CE13-0012

211 THERESA STREET

CODE ENFORCEMENT OFFICER

NOVEMBER 8, 2021

211 Theresa St

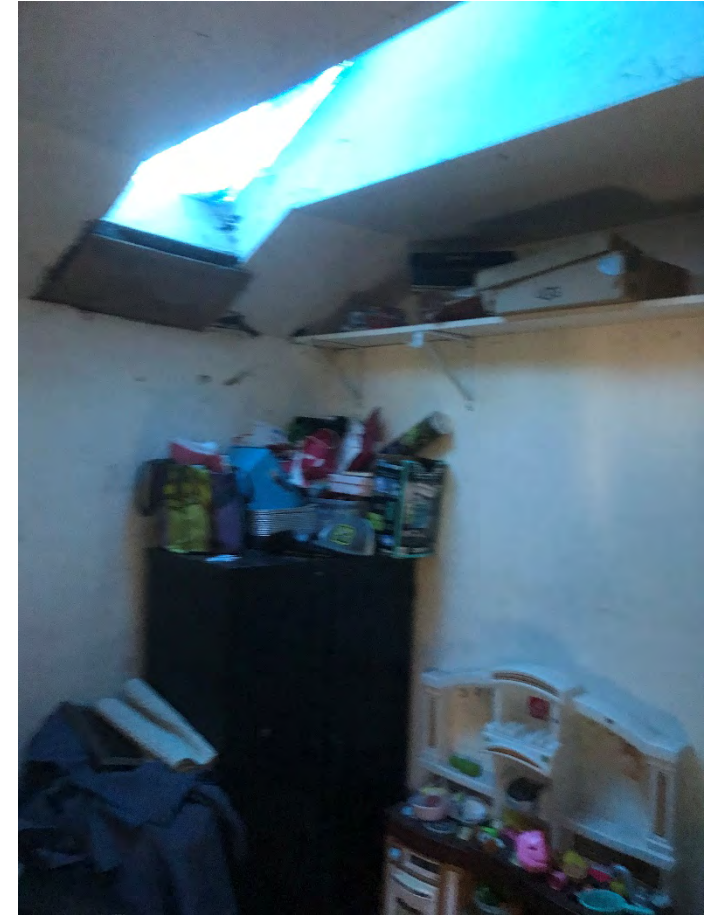
Unapproved materials used to cover detached garage walls
penetration in fire rating, required 5/8 or 1/2 inch gypsum board

Detached garage door covered without benefit of permit
